DEVELOPMENT APPLICATION ASSESSMENT REPORT

Application Number:	DA2025/0817
----------------------------	-------------

Responsible Officer:	Alex Keller
Land to be developed (Address):	Lot 25 DP 7568, 38 King Street MANLY VALE NSW 2093
Proposed Development:	Alterations and additions to a dwelling house including a detached studio
Zoning:	Warringah LEP2011 - Land zoned R2 Low Density Residential
Development Permissible:	Yes
Existing Use Rights:	No
Consent Authority:	Northern Beaches Council
Land and Environment Court Action:	No
Applicant:	Matt Elkan

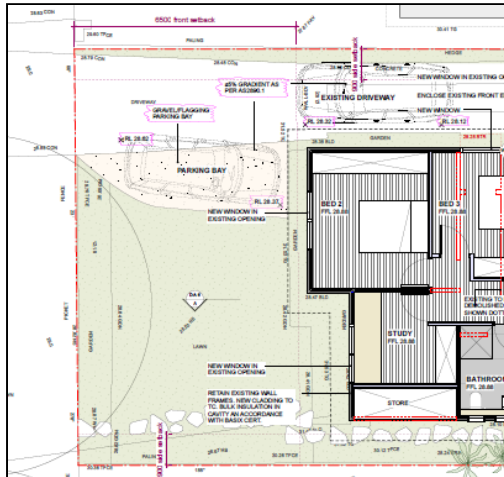
The parking arrangement shown with one car along the side setback (as existing) and one car able to park adjacent the driveway in the front setback will not create an unreasonable impact on King street for the urban surroundings. The car parking is open style and also allows a third visitor space to parking on site (tandem) with the space / arrangement proposed.

The parking arrangement is consistent with surrounding properties and does not cause a loss of street parking or seek any structures (such as an enclosed / semi enclosed garage). Therefore the openness of the front yard is maintained and yard / grassed area is still retained across more than 50% of the front yard.

Amended plans were provided to adjust the parking area and comply with AS / engineering standards.

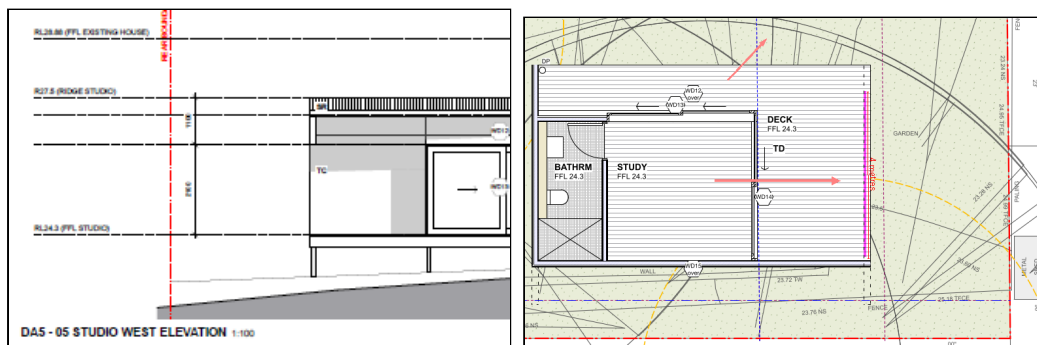
The rear studio outbuilding has a deck facing north into the neighbours rear yard. The floor of the studio is partly elevated due to the cross slope and therefore create privacy imposition in overlooking toward the north above the fence in a setback of less than 6.0m. A privacy screen to restrict overlooking from the deck to the north is recommended as the studio is intended to be capable of used day and night with bathroom and power connections and a wide rear covered deck. The landscape plan shows some mixed screen planting and this will assist to also provide screening to the neighbour. A condition is recommended for a 1.65m batten screen across the middle half of the deck.

setback. This is an unnecessary encroachment long the western common boundary setback (very close if intended for BBQ use, noting the rear deck appears to also have a bbq) and being in the side setback encroachment is to be deleted (by condition) from the landscape plan.

A 1.65 metre high privacy screen (measured from finished floor level 24.3) is to be erected for not less than 4.0 metres along the outermost northern edge of the northern deck located off the studio outbuilding (as shown on the approved plans). The privacy screen shall be of fixed panels or louver style construction (with a maximum spacing of 20mm), in materials that complement the design of the approved development.

The "BBQ bench" as shown on the Landscape Plan is to be situated not less than 0.9m setback (if constructed) from the side boundary to comply with minimum side setback requirements as per Warringah DCP.
